**Additions and Renovations  
Platt Technical High School  
Milford, CT**

**ADDENDUM NO. 2**

July 29, 2019

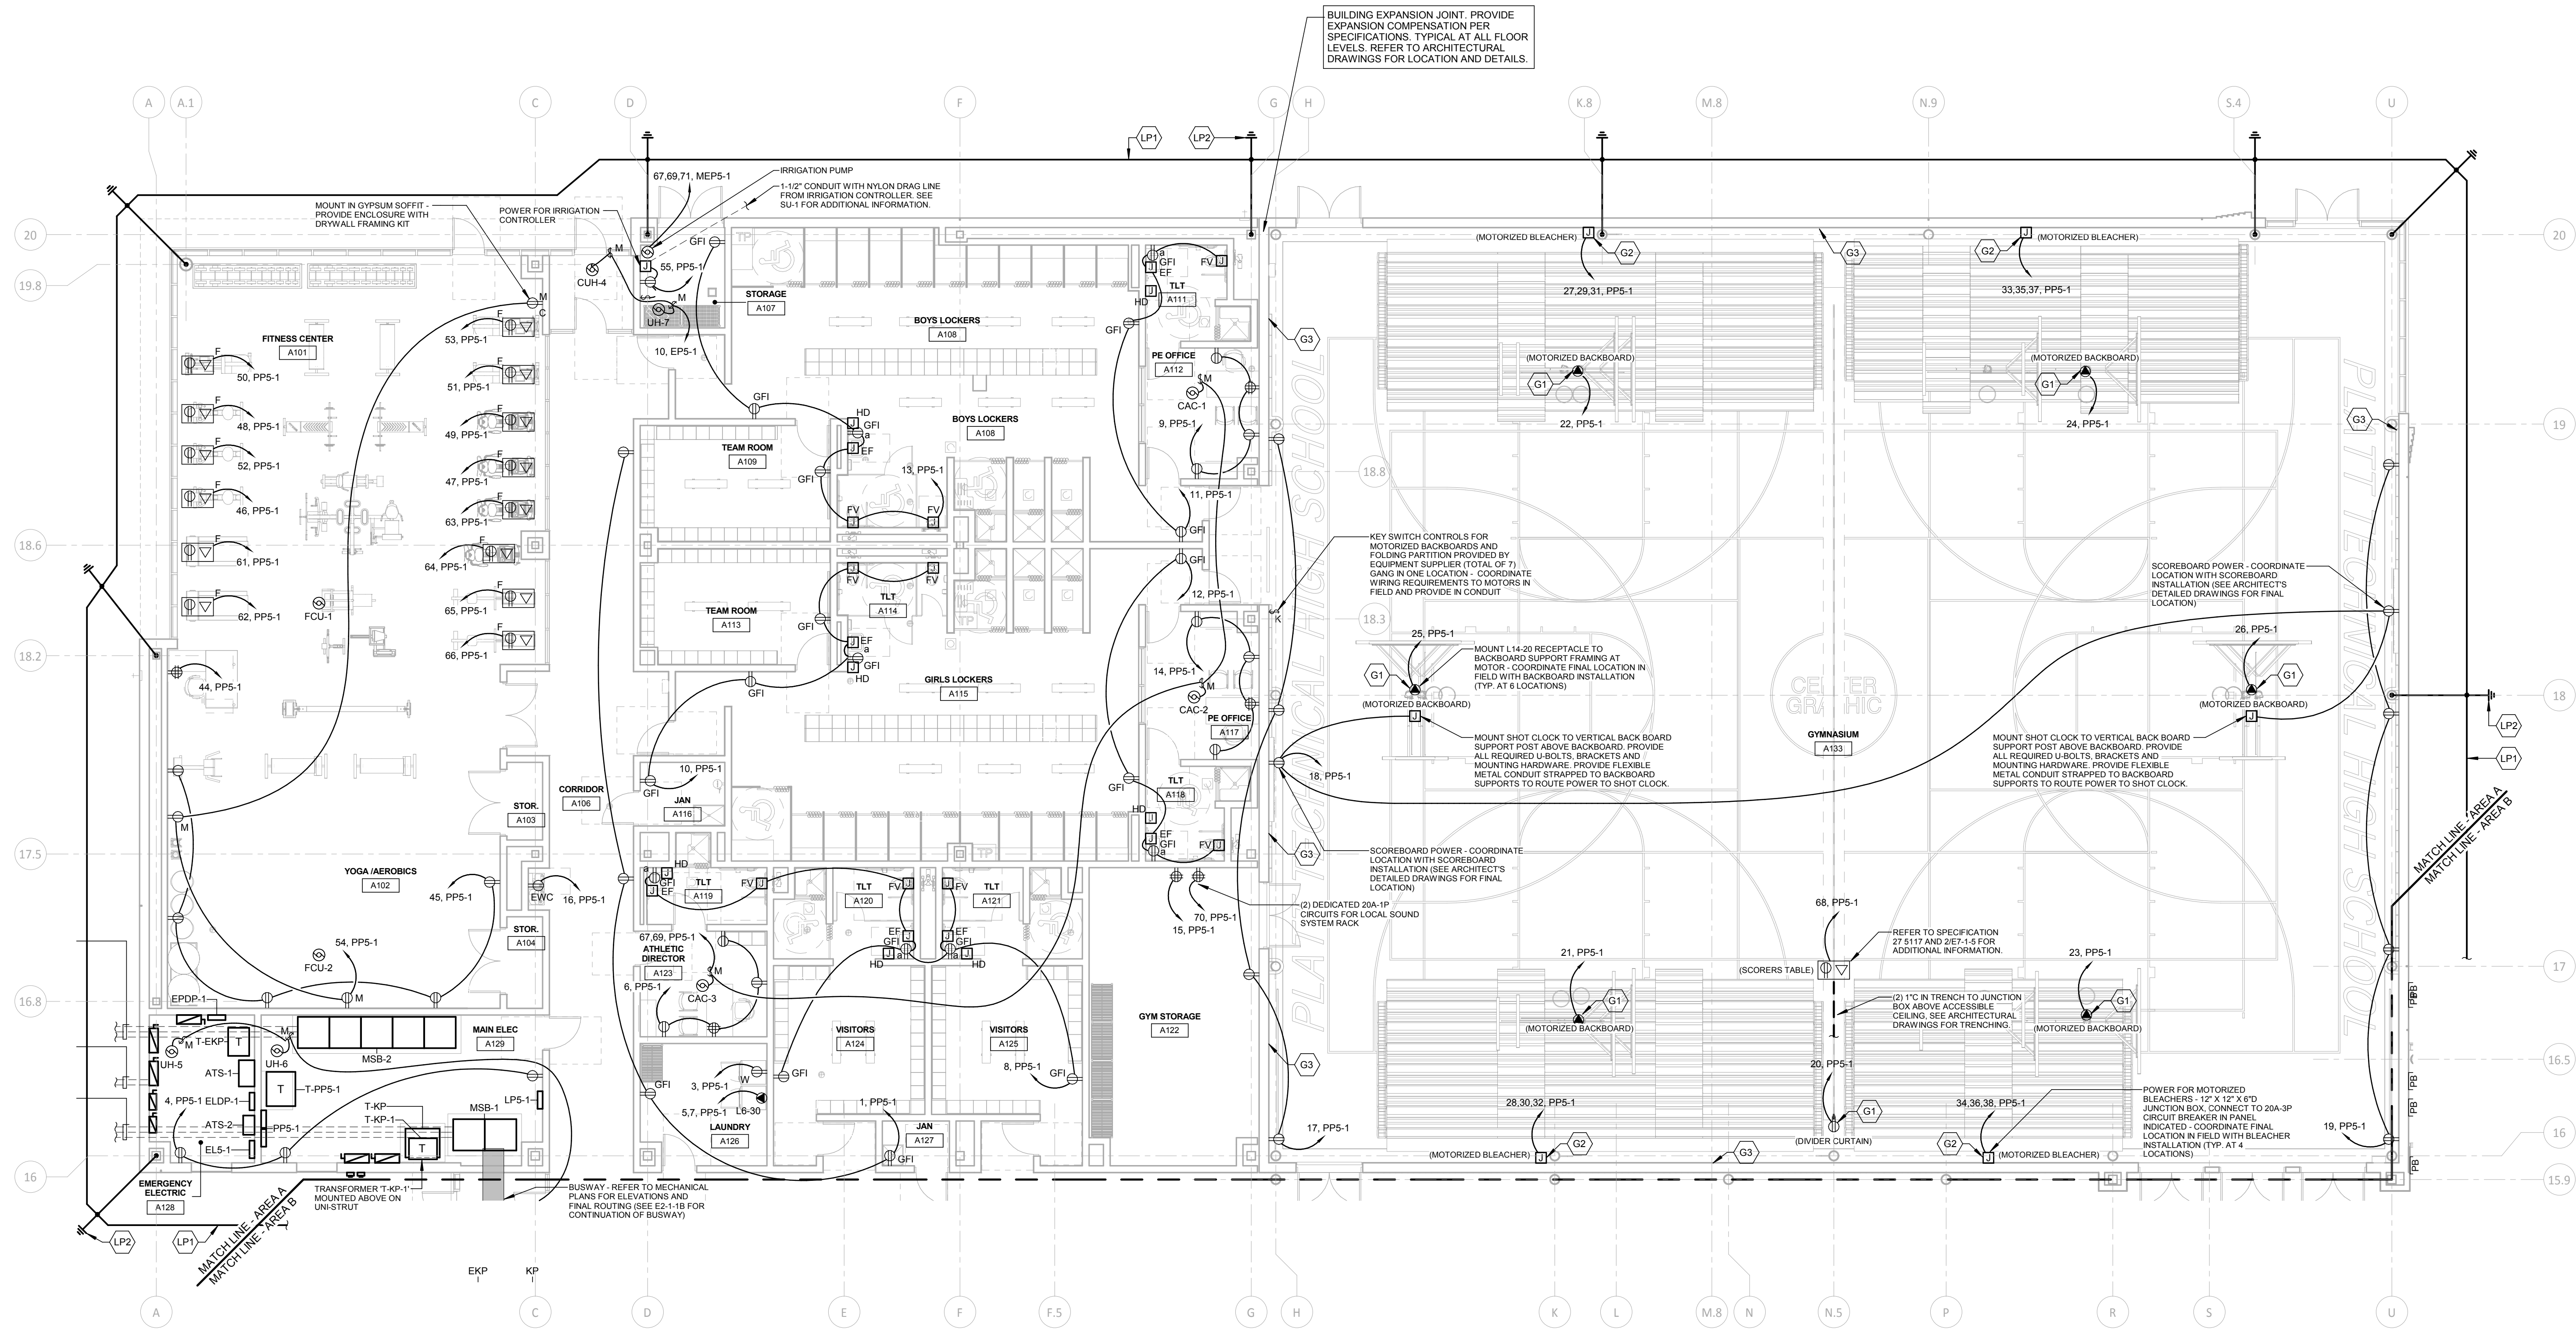
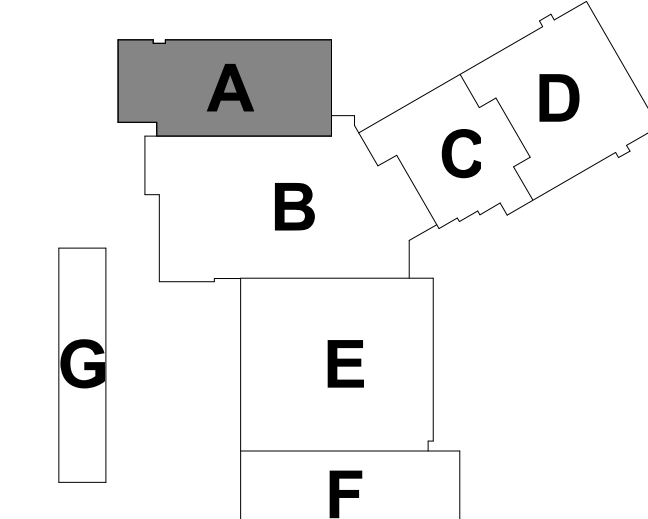
- ADD 2-044      DRAWING E2-1-1A – FIRST FLOOR ELECTRICAL POWER PLAN AREA A**  
Added general note for additional information on shop equipment. Typical of all E2-X-XX series drawings per Revision RE2-11.

drawing title	FIRST FLOOR ELECTRICAL POWER PLAN AREA B
drawing no.	E2-1-1B
project	ADDITIONS AND RENOVATIONS PLATT TECHNICAL HIGH SCHOOL
CAD no.	DCS project no. B187-076 C.M.R.
OSCRG project no.	900-0113
date	05/24/2019
scale	As Indicated
drawn by	vsm
approved by	esm
drawing no.	E2-1-1B

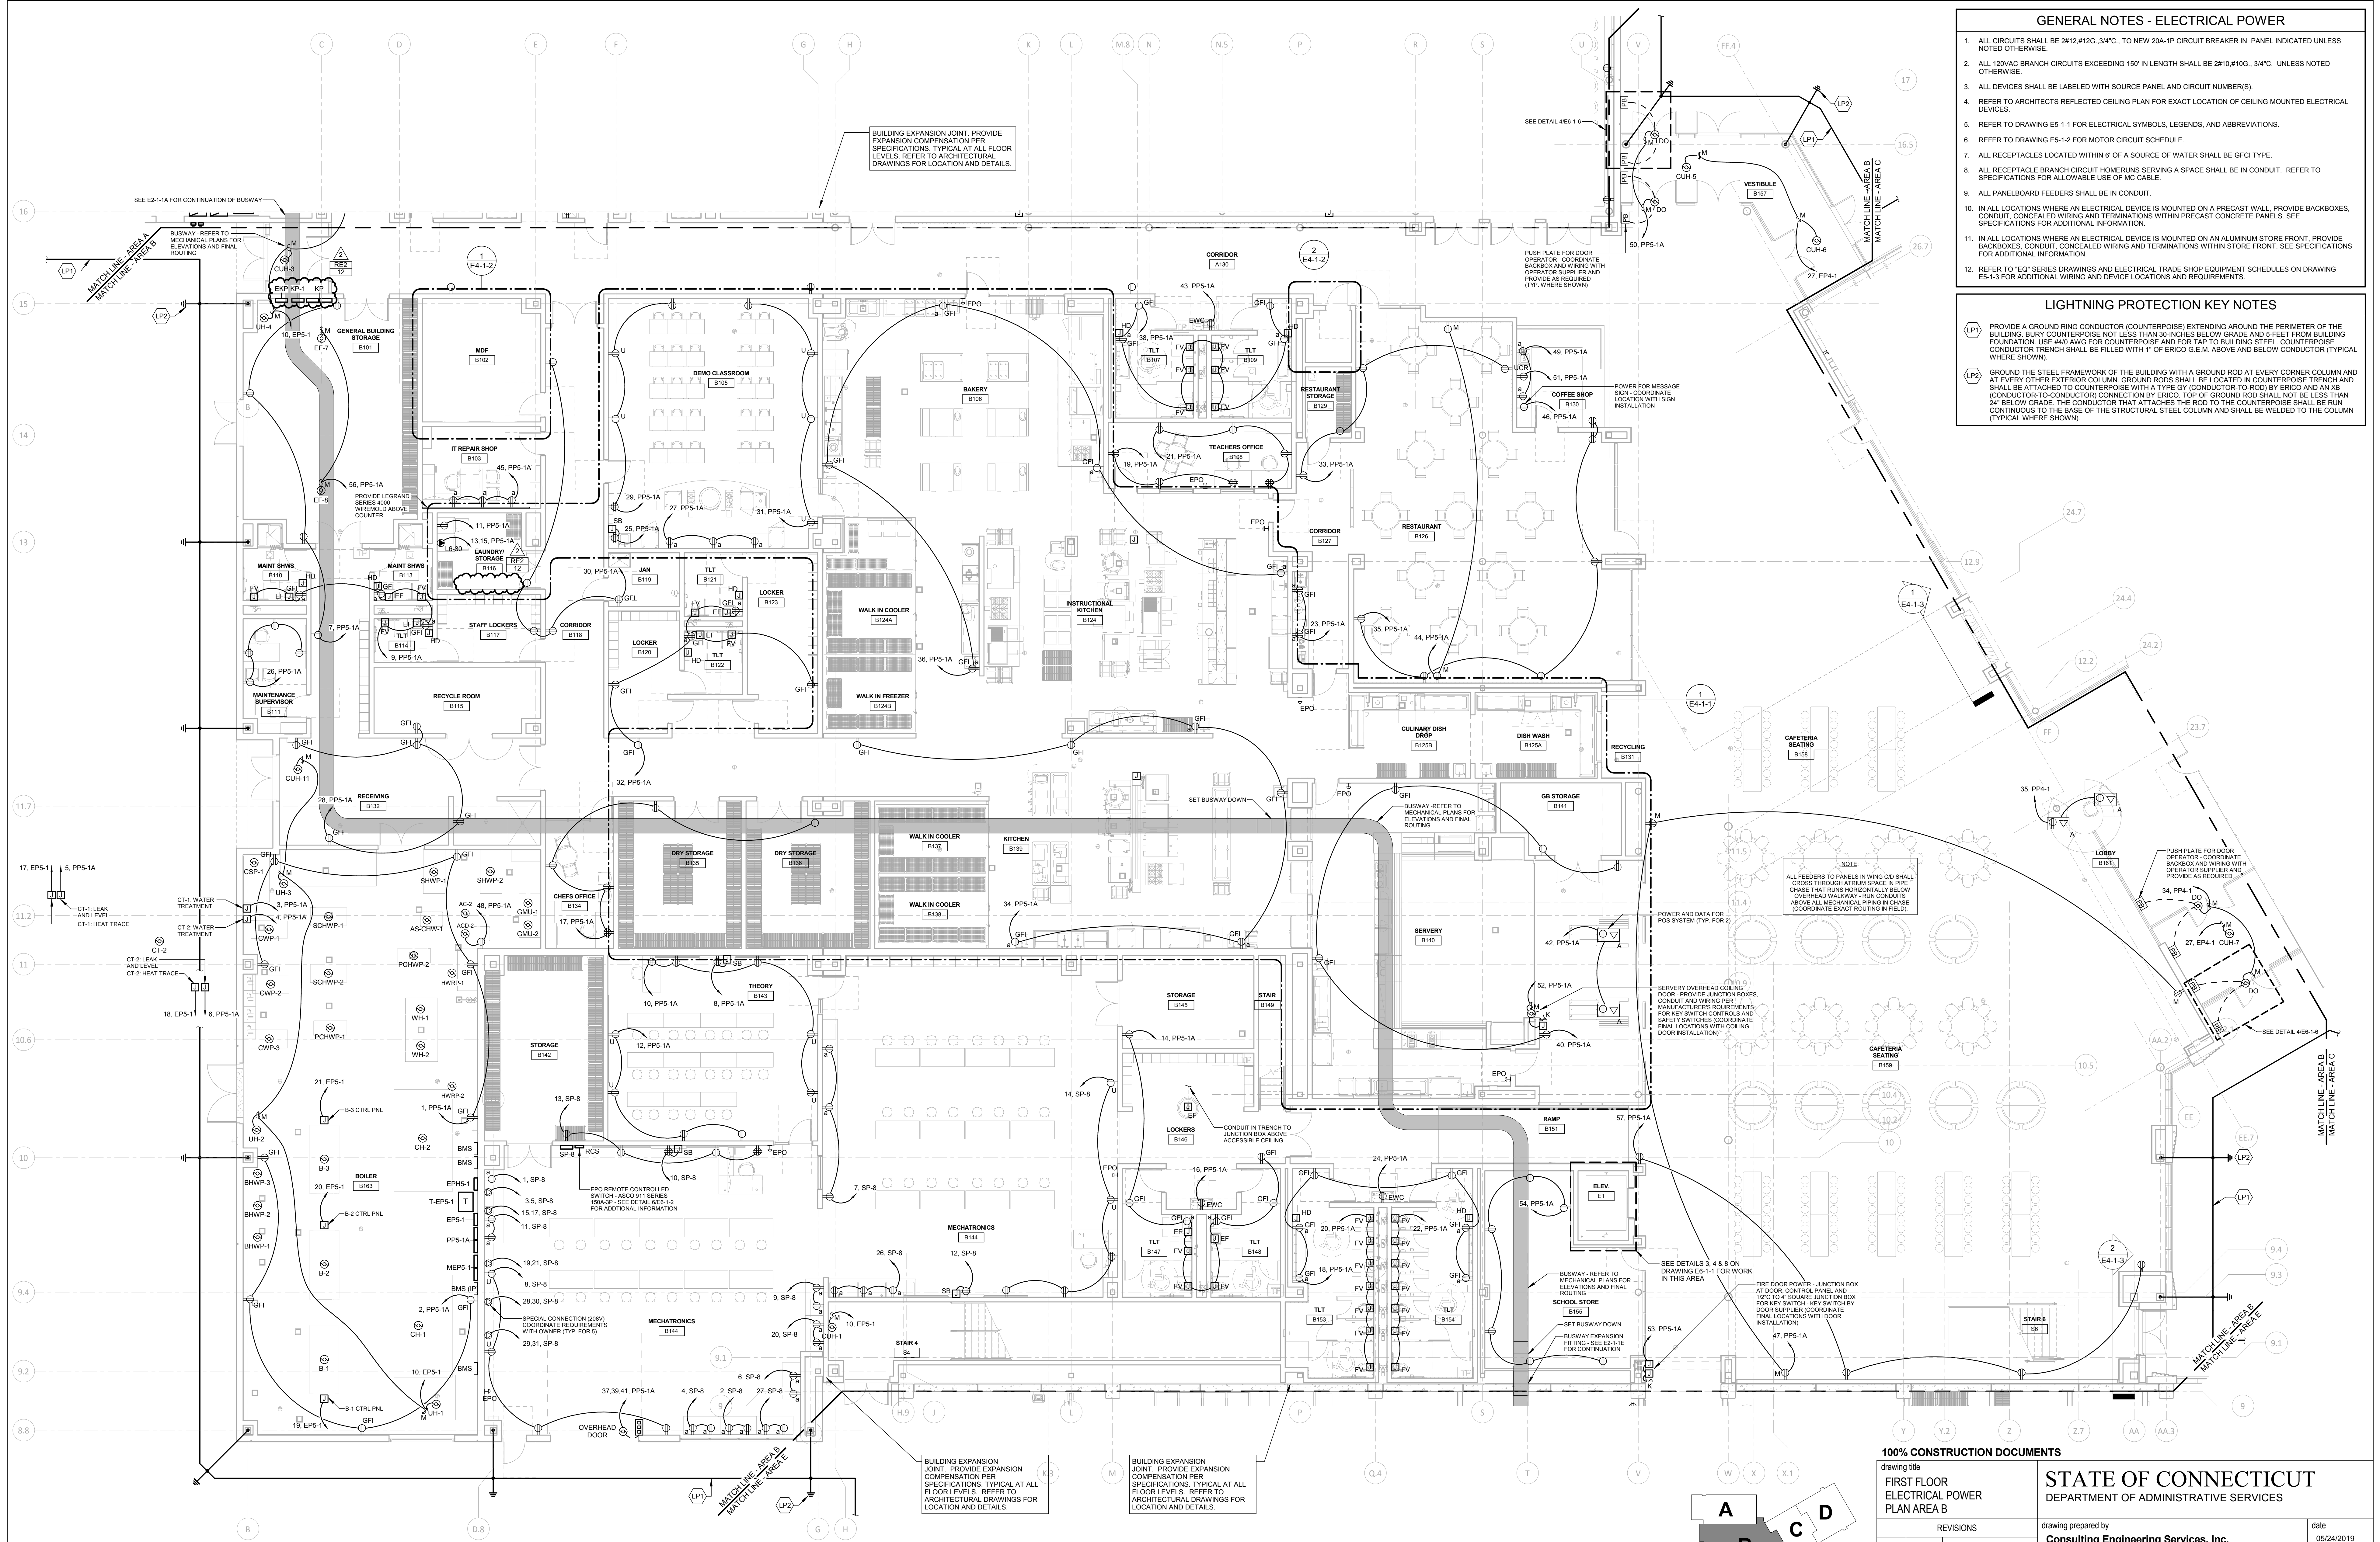
- ADD 2-045      DRAWING E2-1-1B – FIRST FLOOR ELECTRICAL POWER PLAN AREA B**  
Relocated kitchen electrical panels per Revision RE2-12.
